CERTIFICATE OF APPROPRIATENESS

Property: 634 W. Cottage

Proposal: Restore existing facades, add windows, change building entry to eastside

EXTERIOR RENOVATION
 Hope Lutheran Church

2 East Elevation - EXISTING
1/4"= 1'-0"

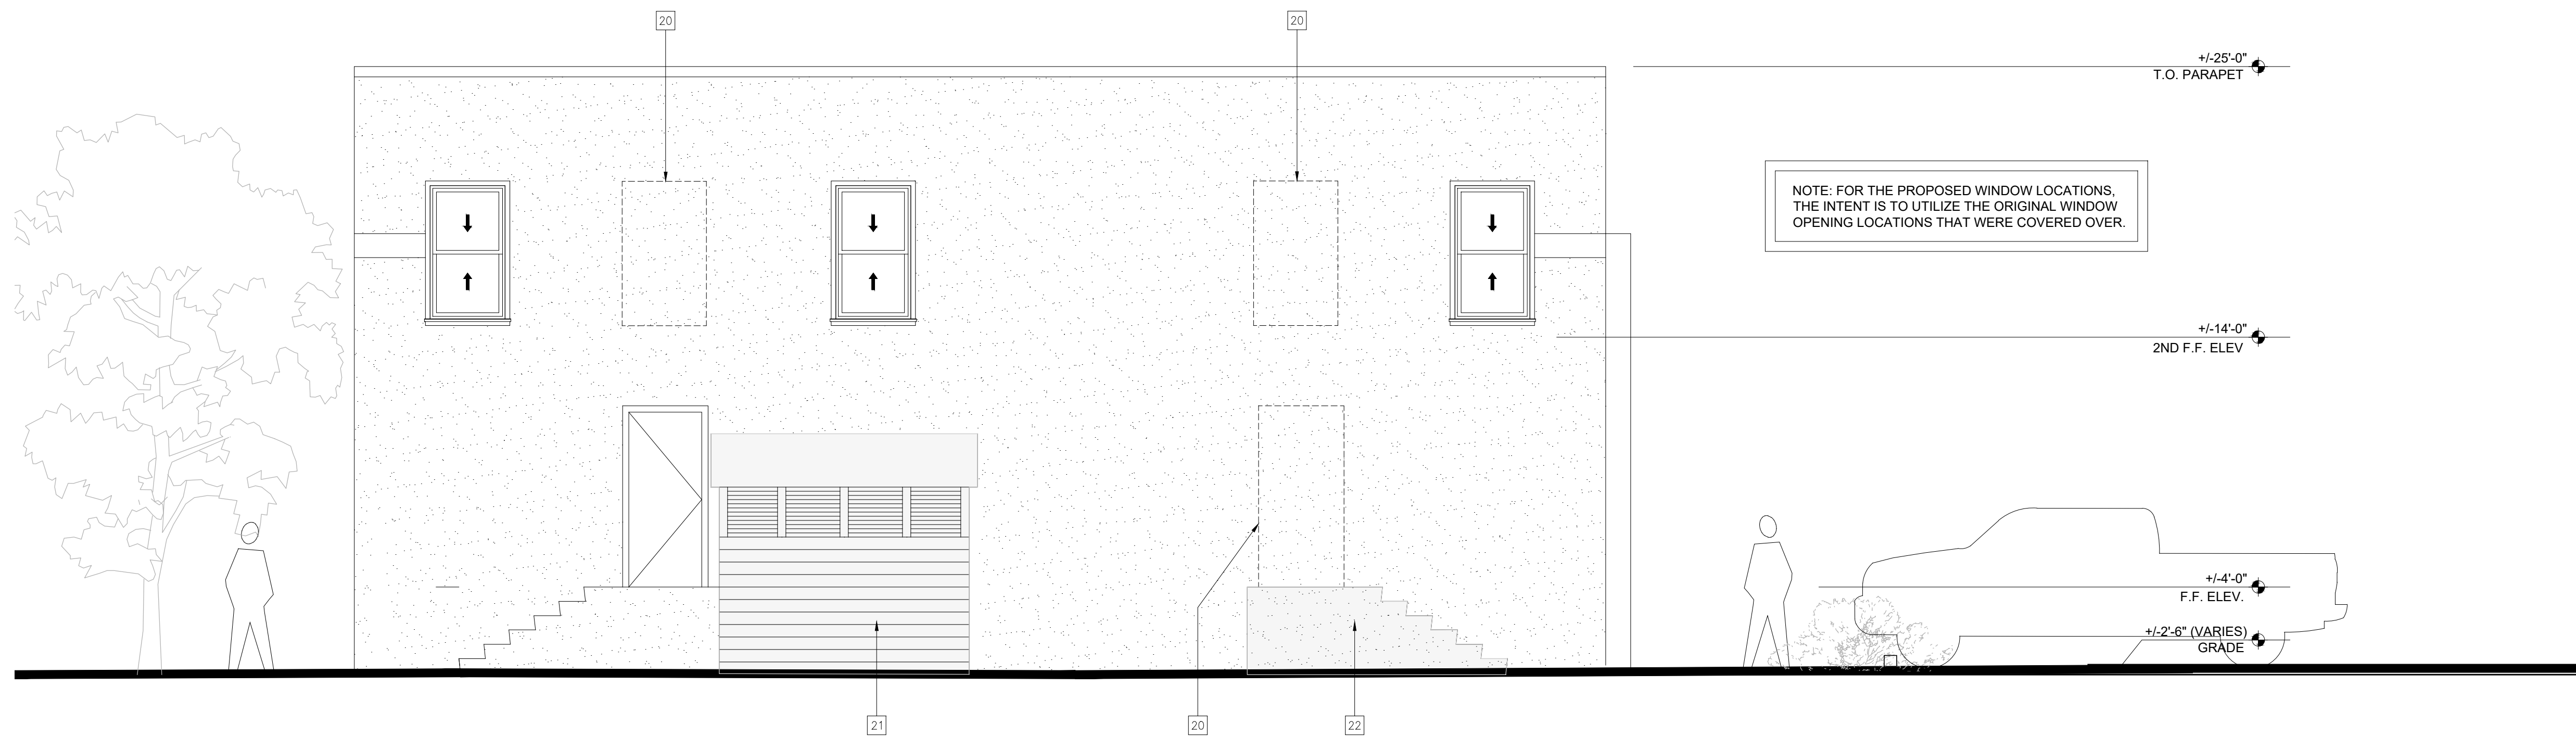
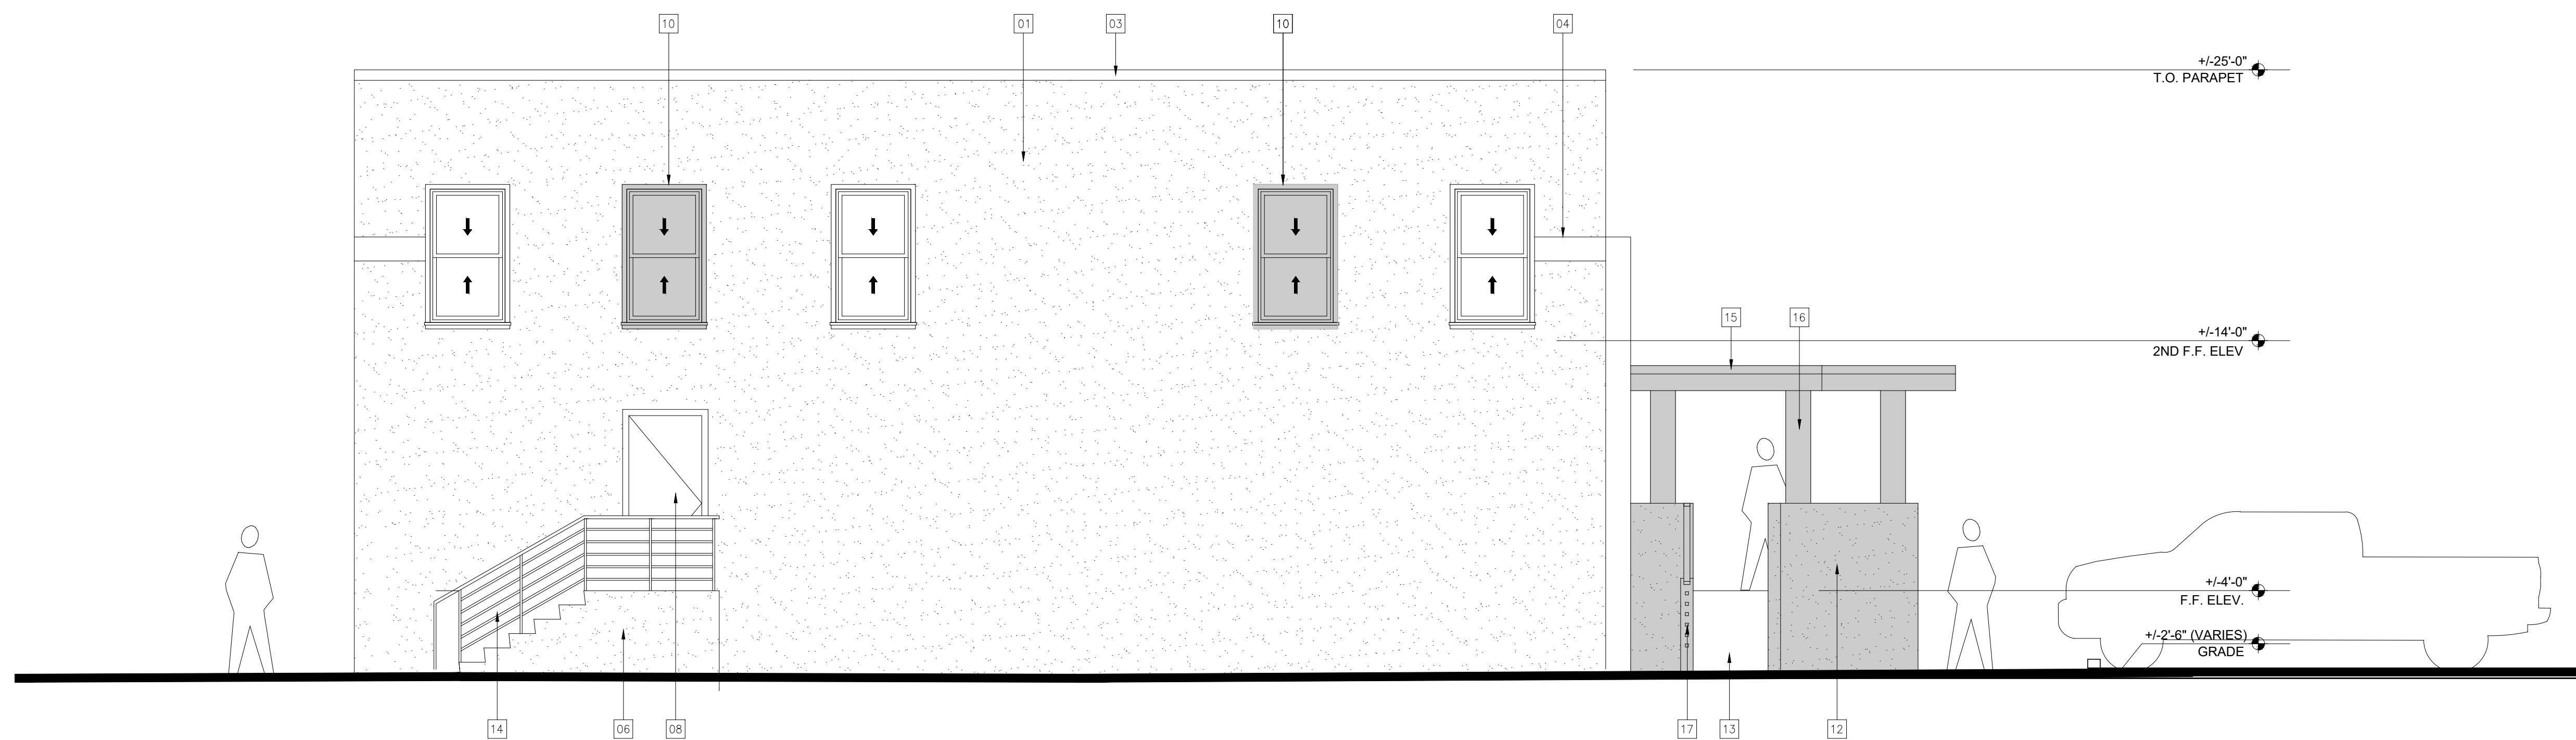
Recommendation: Approval with conditions: wall by accessibility ramp step down to block less of the east elevation.
